# Moisture Survey Inspection

123 Pleasant Lane  
Pleasantville, WA 98000

Sound Exterior Inspections, LLC performed a moisture survey inspection on January 1, 2019 of the EIFS Sprint Barrier System installed on the building located at 123 Pleasantville Lane, Pleasantville, Washington at the request of John Doe, LLC.

# Rear Right Elevation

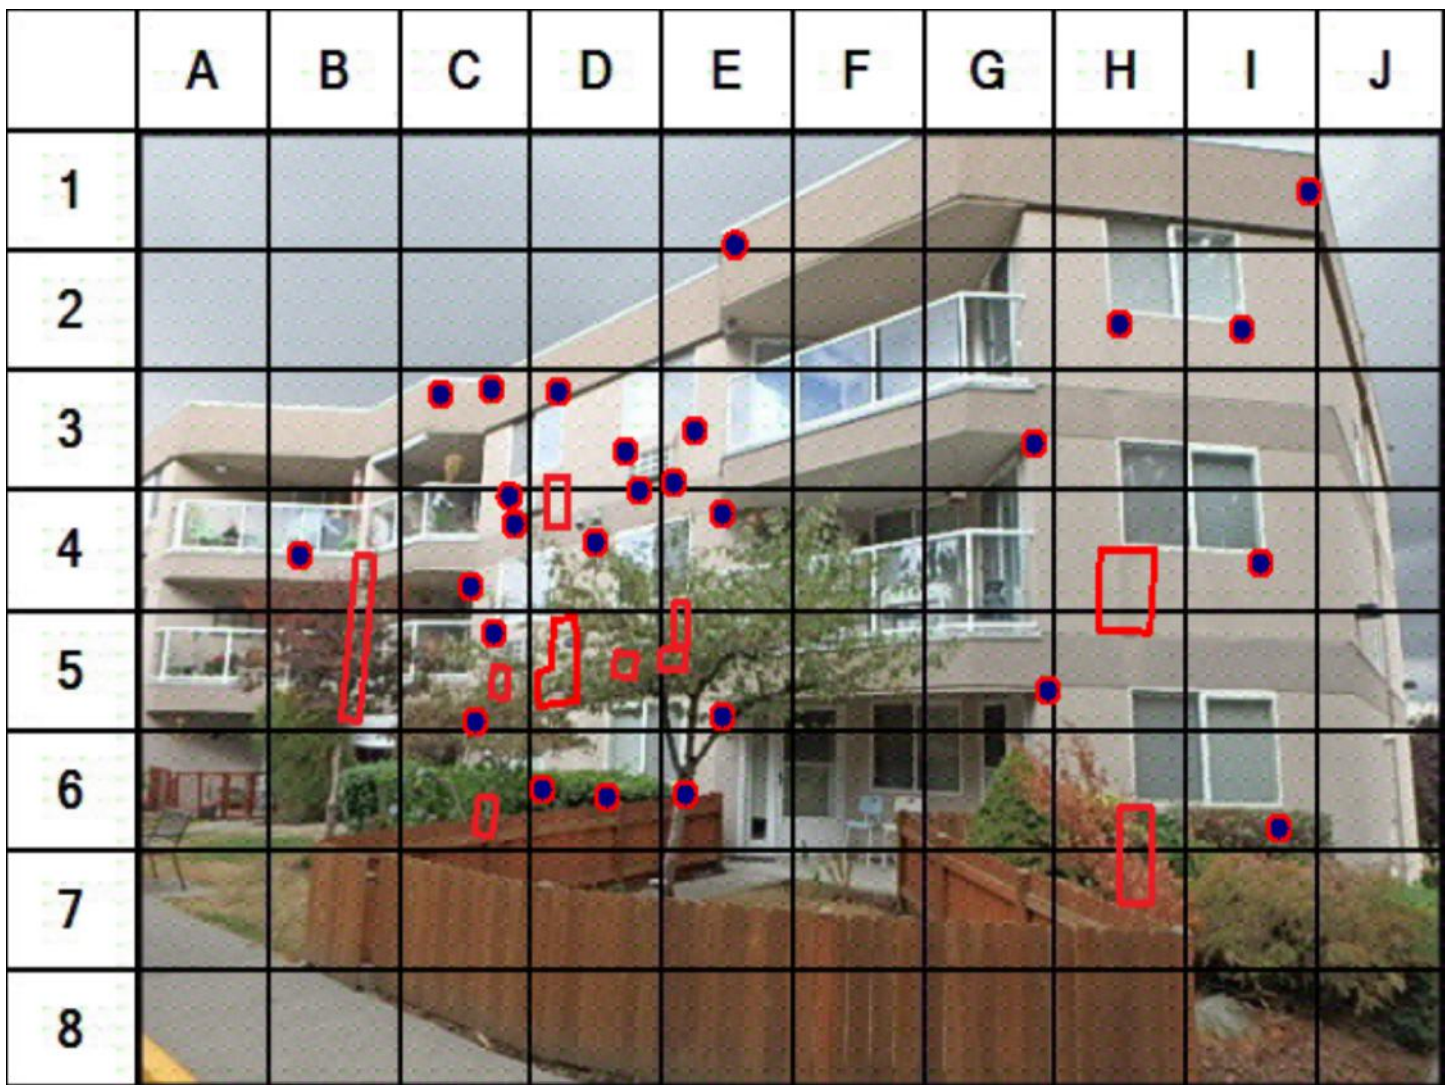
Recommend replacement of deck membrane due to installation details and aging; typical

Deck termination need end dam flashing installation; typical

Inconclusive probing results below deck due to OSB substrate cut out to accommodate steel bracket installation; recommend random intrusive evaluation upon system remediation to determine framing condition; typical

Wood rot detected at deck substrate (B4)

7/8" EIFS needs to be removed at window perimeter prior to base coat and mesh application to accommodate 3/4" silicone sealant joint application; typical

PTAC shroud terminations need remediation to accommodate 1/2" sealant joint application; typical

7/8" EIFS needs to be removed at PTAC perimeter prior to base coat and mesh application to accommodate 3/4" silicone sealant joint application; typical

# Left Elevation

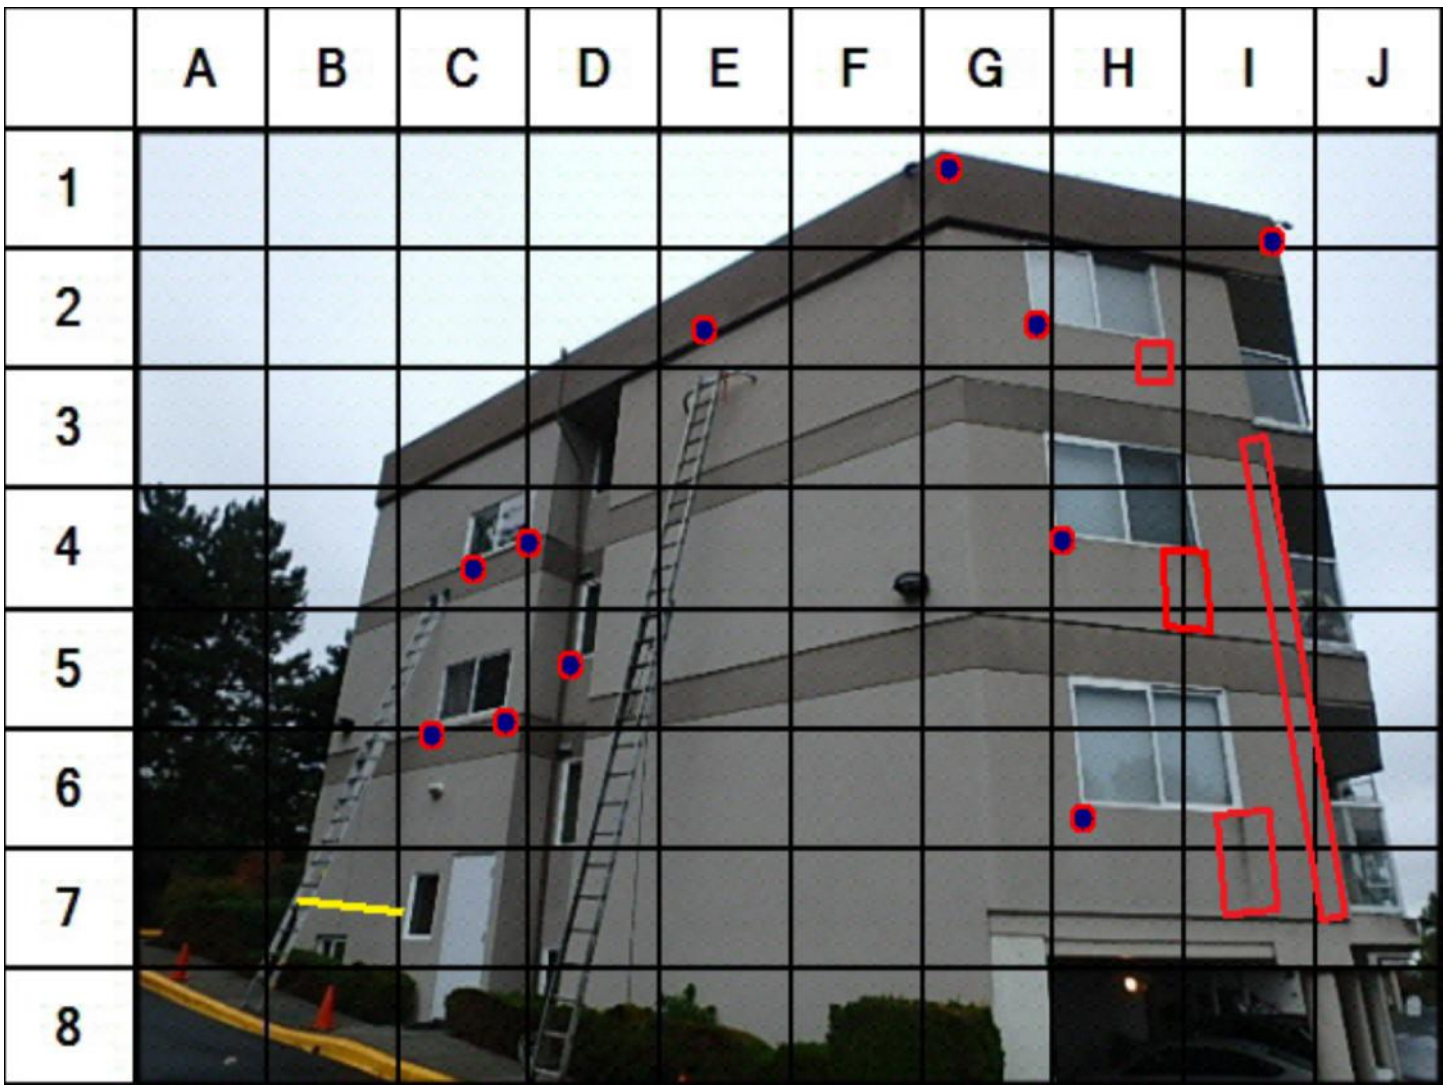
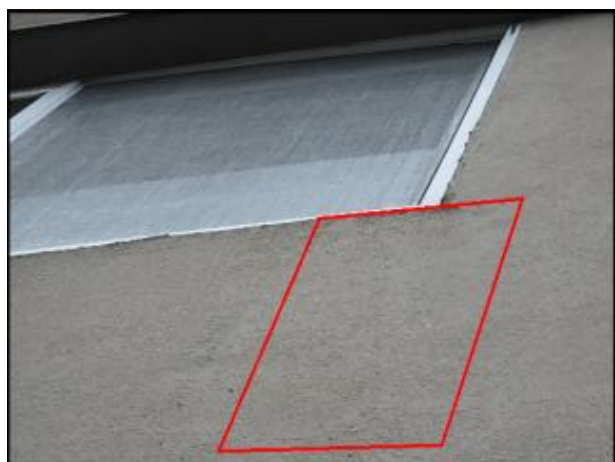
7/8" Sprint board application does not allow for minimum 3/4" foam at base of v-groove; hairline cracks observed; detail needs bond breaker tape and silicone sealant joint application; typical

Crack needs to be gouged and slivered with EPS prior to base coat, mesh and finish coat application; typical

Recommend replacement of deck membrane due to installation defects and failure observed; deck termination needs end dam flashing installation; typical

Railing fasteners need to be sealed; typical
